**PROPOSED
SHANTZ STATION ROAD
GRAVEL PIT:
DEFICIENCIES IN THE APPLICATION**

Dean G. Fitzgerald M.Sc., Ph.D.

HOPEWELL CREEK RATEPAYERS ASSOCIATION

August, 2021

***Core Environmental Features Near Proposed Pit:
Provincially Significant Wetlands***

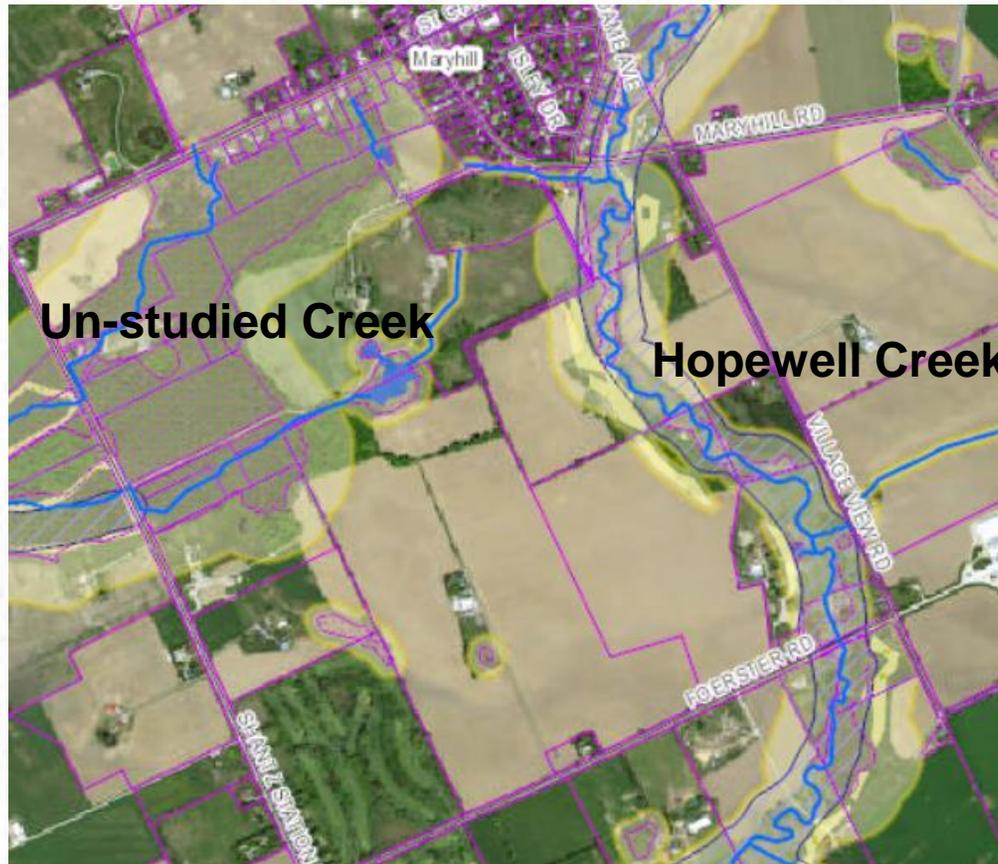
1. Core Environmental Features in Regional Official Plan:
 - Requires study to ensure no disturbance from pit
 - No such studies done due to assumption of no change in water discharge to wetlands
2. Hopewell Creek
 - Requires study to ensure no disturbance from pit
3. Two branches of an unnamed creek north side of pit
 - No studies completed
 - Requires study to ensure no disturbance from pit
4. No risk assessment of environmental features

***Environmental Features Near Proposed Pit:
Creeks that were not studied***

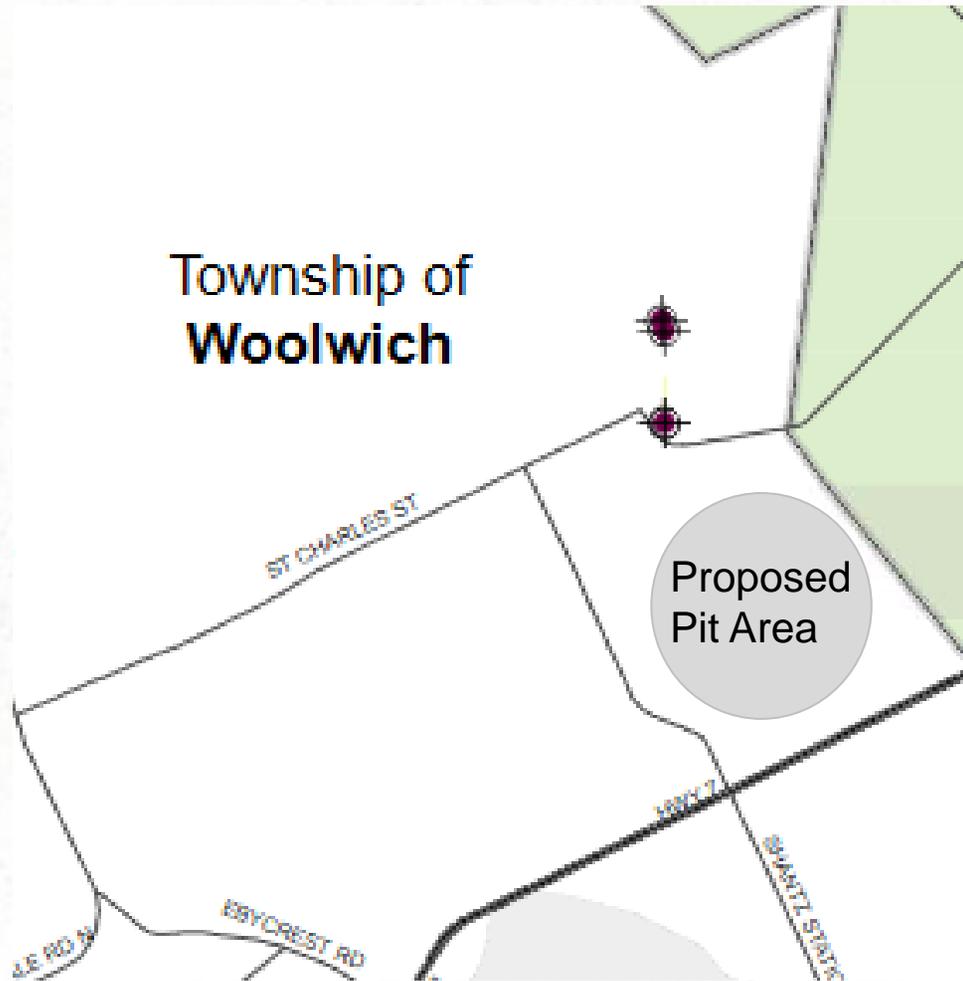
1. No scenario of risk of disturbance for two creeks:
 - No disturbance scenario resulted in no detailed studies of Hopewell Creek or un-named tributary

1. Proposed pit included no scenario of water loss in creeks:
 - Potential for lost water volumes to Hopewell Creek
 - Potential for lost water volumes to unnamed creek
2. Proposed pit included no analysis of water chemistry:
 - Potential for degraded water to Hopewell Creek
 - Potential for degraded water to unnamed creek
3. Proposed pit included no analysis of water temperature:
 - Potential for warmer water to Hopewell Creek
 - Potential for warmer water to unnamed creek
4. Changes in water quantity or chemistry not assessed
